## Response to Submissions Section 75W to Concept Plan (MP08\_0116)

### UTS City Campus, Broadway Precinct GFA and Building Envelope Amendments

Submitted to Department of Planning and Environment  
On Behalf of University of Technology Sydney

**Figure 1** – Comparison of proposed modification envelope (left image) and indicative design scheme (right image)

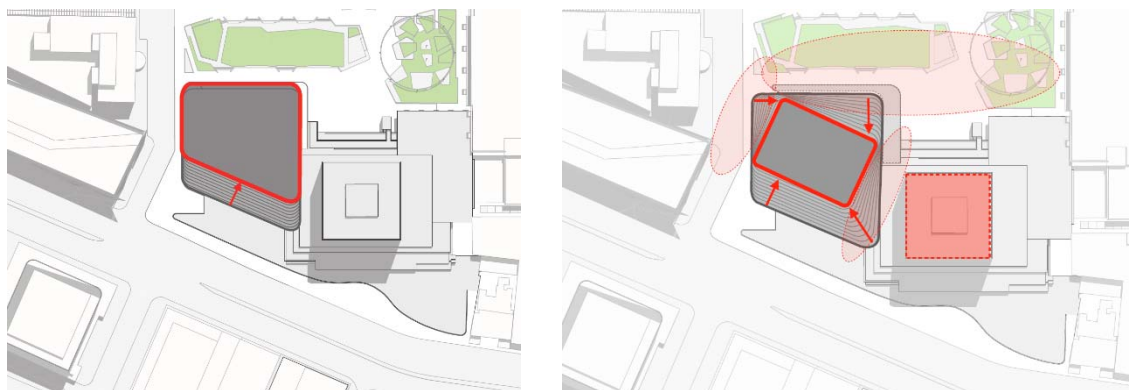
Council raises concern over the separation distance provided between the proposed addition to Building 2 and the Building 1 tower, suggesting that the separation distance should be increased to ensure that the setting of Building 1 tower is more clearly defined.

The Department also requests further analysis and consideration of greater building separation and a lower street wall.

**Figure 1** below illustrates diagrammatically the approach to the indicative design and how this compares to the proposed building envelope. The eastern setbacks for Building 2 now under consideration in the indicative design from Building 1 are (refer to **Figure 2**):

**Figure 5** – Design progression in Building 2 form from modification envelope to indicative design

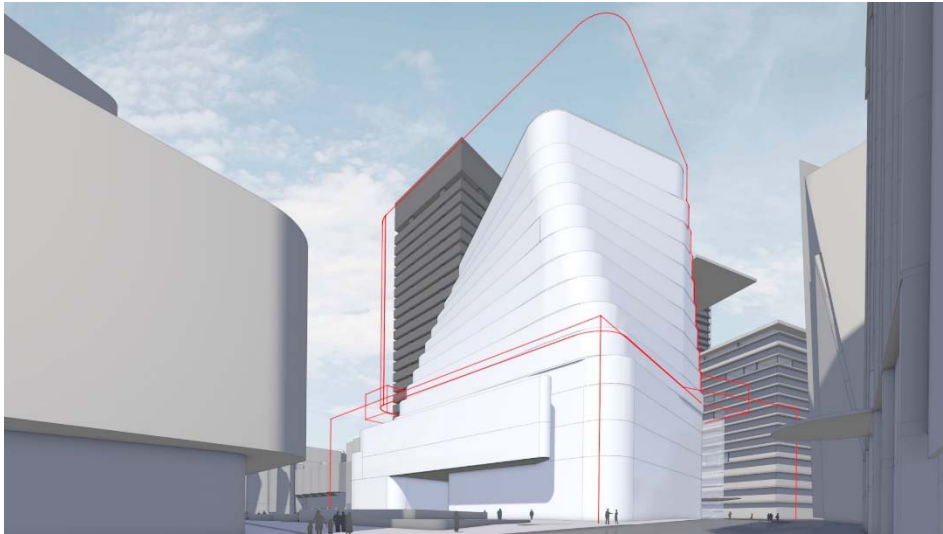
Council also recommends that the eastern side of Jones Street should maintain a low scale street wall, responding to the scale of the nearby heritage listed former Sydney Technical College Building (Building H).

As a flow on effect of the rotating of Building 2 within the indicative design scheme, the form is progressively setback from Jones Street as the building increases in height. The incremental stepping back of the form begins at level 7 which helps to more clearly define the street wall along Jones Street and Alumni Green. **Figure 5** provides a simple illustration of the progression in the design from the modification envelope to the indicative design scheme and how a low scale street wall is being established and supported along Jones Street.

The progressive stepping back of the indicative design scheme form from Jones Street also provides much greater separation between the proposed Building 2 form and Building 10 giving this building improved visual prominence.

**Figure 8** – Extract from the Visual Impact Assessment comparing the approved Building 2 envelope (left) and the proposed modified envelope (right)

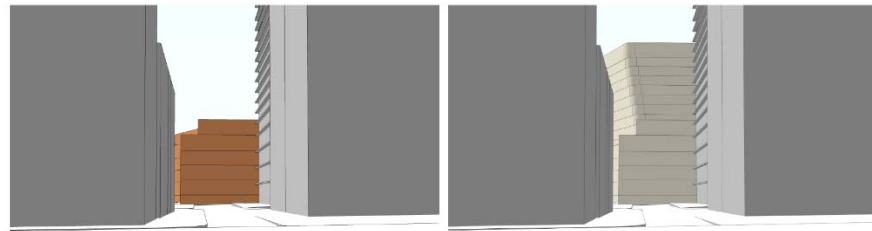
Council consider that the proposal compromises the value of Balfour Street by reducing the view to open sky and creating a solid wall of built form at the termination of the street.

Council therefore recommend that the modification to the approved envelope should be amended to acknowledge the eastern alignment of Balfour Street, and to retain a greater view of sky above the approved Building 2 podium.

Council's comments are noted, however these need to be considered in the context of the site's location on the fringe of the CBD along with pedestrian wind conditions (refer to **Appendix C**).

**Figure 8** below provides an extract from the Visual Impact Assessment of the view corridor in question.
